LEReC Meeting Presentation with Meeting Minutes

(LEReC) Low Energy RHIC electron Cooling Project

TOPIC: LEReC Engineering Meeting – RHIC Cooling Section Beam Line Cooling Section Solenoid/Corrector/Vacuum Chamber mechanical design

Meeting Minutes: LEReC Engineering Meeting – RHIC Cooling Section Beam Line Cooling Section Solenoid/Corrector/Vacuum Chamber mechanical design 9 17 2014

Focusing Solenoid for (Higher Energy)

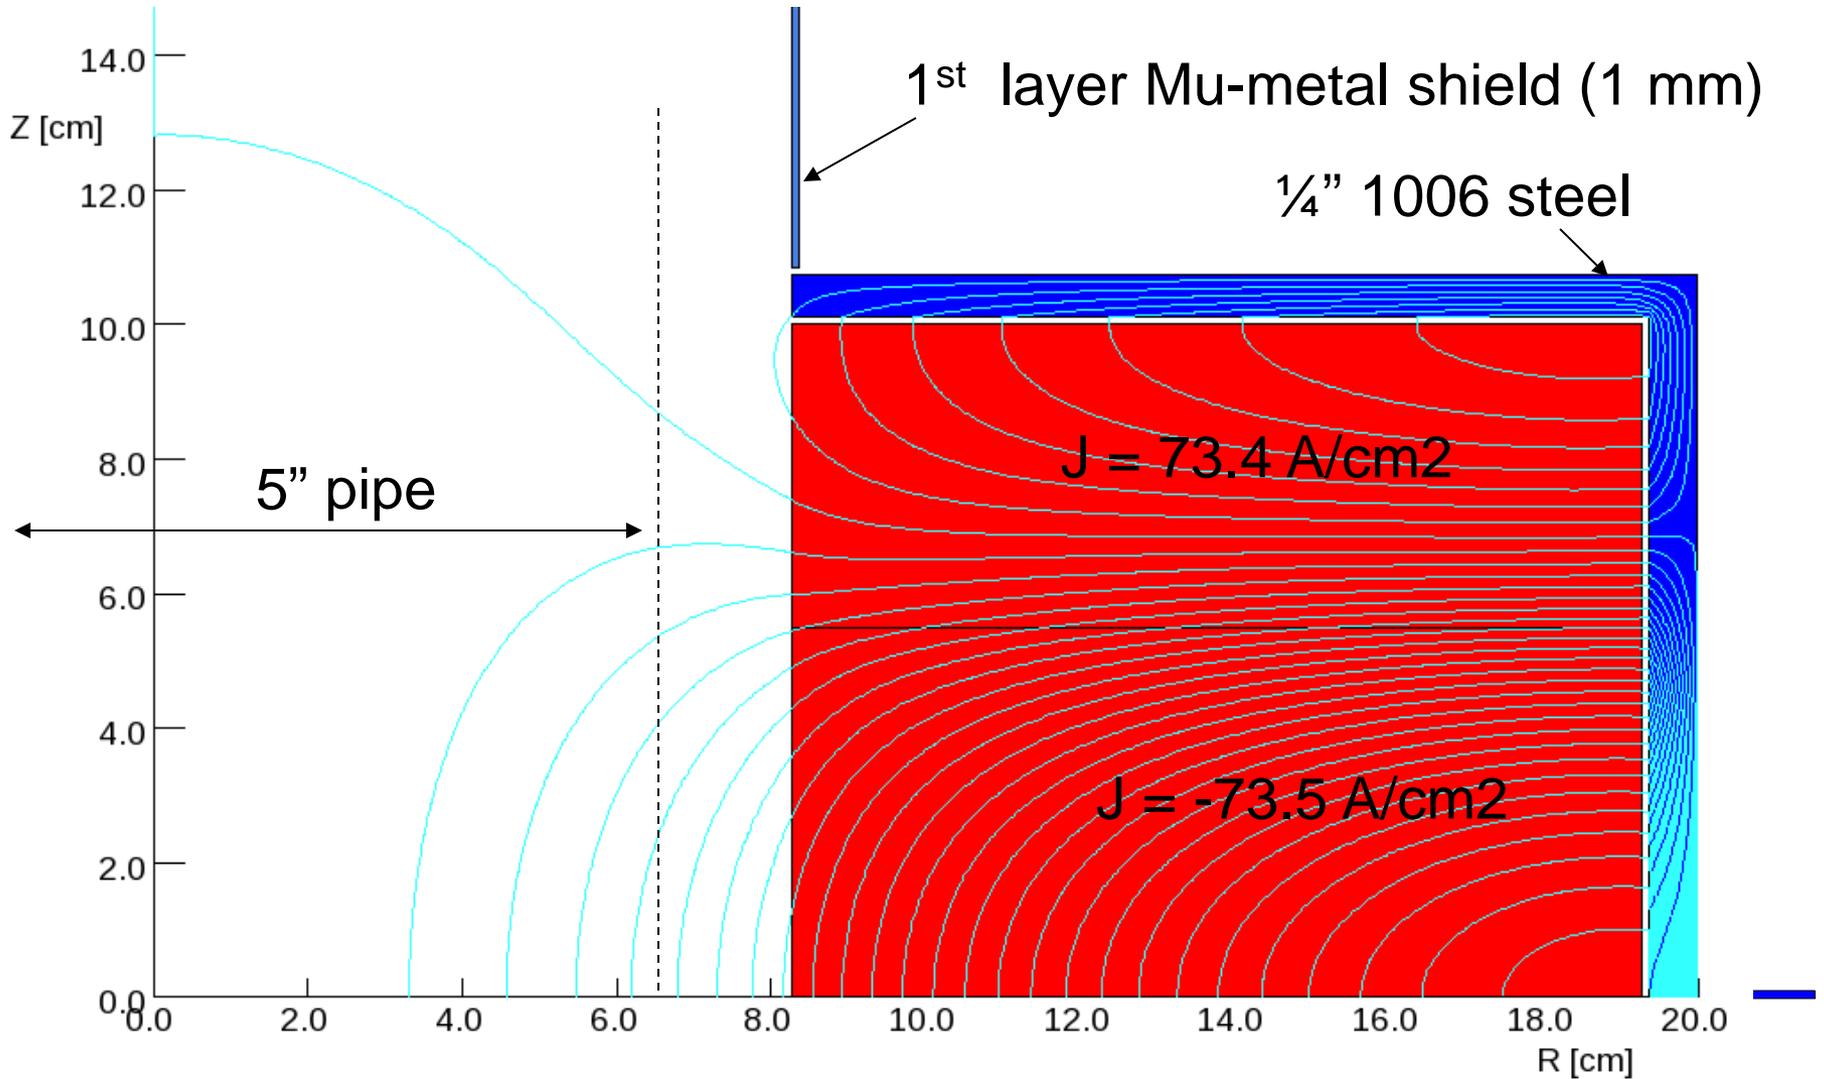
1. Compensating Solenoid correction end coils: It was noted that the length for the solenoid given on the white paper was 16 cm; but, the length of the modeled solenoid presented in slide 4 was 21 cm. The latest solenoid design has correction solenoid coils at both ends to reduce the solenoid end field into the cooling section. This continues to be a design requirement. W. Meng has designed the end correction solenoid coils so that they can be powered in series with the main coil. At this time the modeled solenoid field is 0.17 kG; the requirement is 0.20kG.
